RIVERCHASE ESTATES SUBDIVISION,
RESUBDIVISION AND ADDITION TO LOTS 17-21

APPLICATION NUMBER 17 DATE September 4, 2008

REQUEST Subdivision

DETAIL SITE PLAN

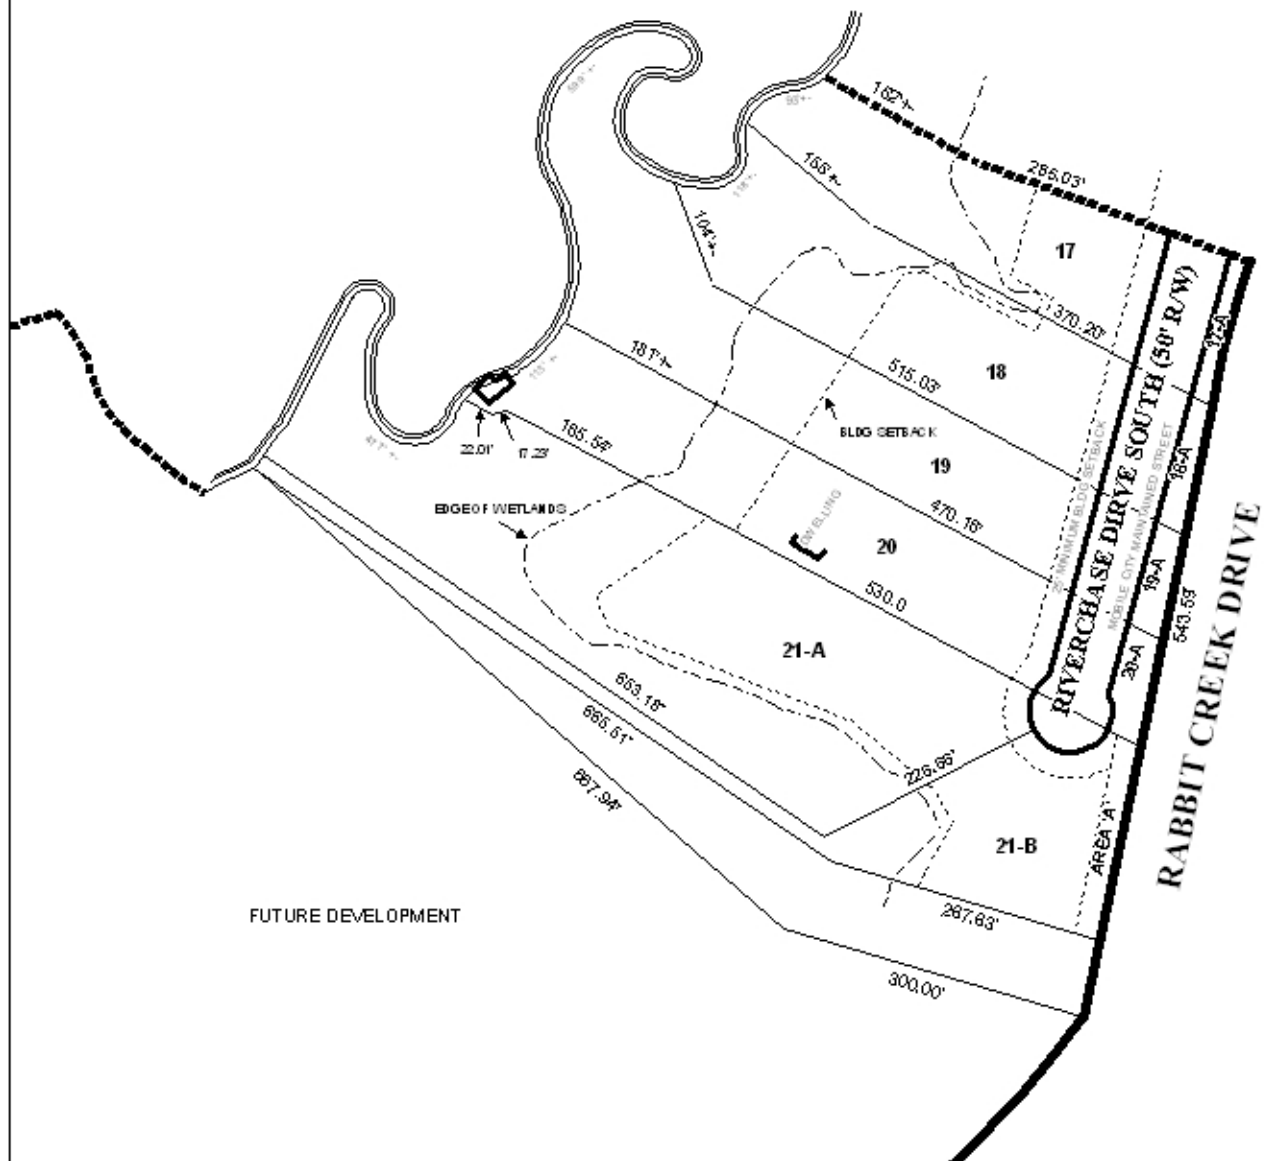
Lots 17-21-A of the proposed subdivision fronts Riverchase Drive South, which has 50-feet of right-of-way. Lots 17A-20A front Riverchase Drive South and Rabbit Creek Drive, a minor street with an unspecified right-of-way (right-of-way width is 60-feet according to the plat recorded in 1996; however the plat under consideration provides no right-of-way information. It should be noted that, dedication to provide 30-feet from the centerline of Rabbit Creek Drive

As a means of access management, Lots 17, 18, 19, 20, 21A and 21B should be allowed one curb cut to Riverchase Drive South, and conform to AASHTO standards. Furthermore Lot 21B and Lots 17A through 20A should be denied access to Rabbit Creek Drive.

The proposed addition of a portion of the metes and bounds parcel proposing Lot 21B would create a lot split between the City of Mobile and the Planning Jurisdiction. Therefore, the owner of the lot should petition the city to take this portion within its jurisdiction.

As proposed, Lots 17, 18, 19, 20, 21A and 21B would exceed the depth-to-width ratio of Section V.D.3. of the Subdivision Regulations; however, narrow, deep lots are typical of waterfront properties within the area and this would be typical of the neighborhood.

Wetlands exist on a portion of the site as illustrated on the plat. The site may also be within the floodplain of Rabbit Creek; the presence of wetlands as indicated on the preliminary plat the area may be environmentally sensitive; therefore, if approved, the approval of all applicable federal, state and local agencies would be required prior to the issuance of any permits or land disturbance activities.

- 1) the dedication of sufficient right-of-way to provide 30-feet of right-of-way from the centerline of Rabbit Creek Drive;
- 2) placement of a note on the Final Plat stating that Lots 17, 18, 19, 20, 21A and 21B are limited to one curb, with the size, location, and design to be approved by Traffic Engineering and conform to AASHTO standards;
- 3) the placement of a note on the Final Plat stating that Lot 21B and Lots 17A through 20A are denied access to Rabbit Creek Drive;
- 4) certification via placement of a note on the plat stating that the property owner/developer will comply with all local, state and federal regulations regarding endangered, threatened or otherwise protected flora and fauna;

- 5) labeling of each lot with its size in both square feet and acreage, or the furnishing of a table on the final plat providing the same information; and
- 6) the provision that all of Lot 21A is located within the City of Mobile jurisdiction prior to the signing of the Final Plat.
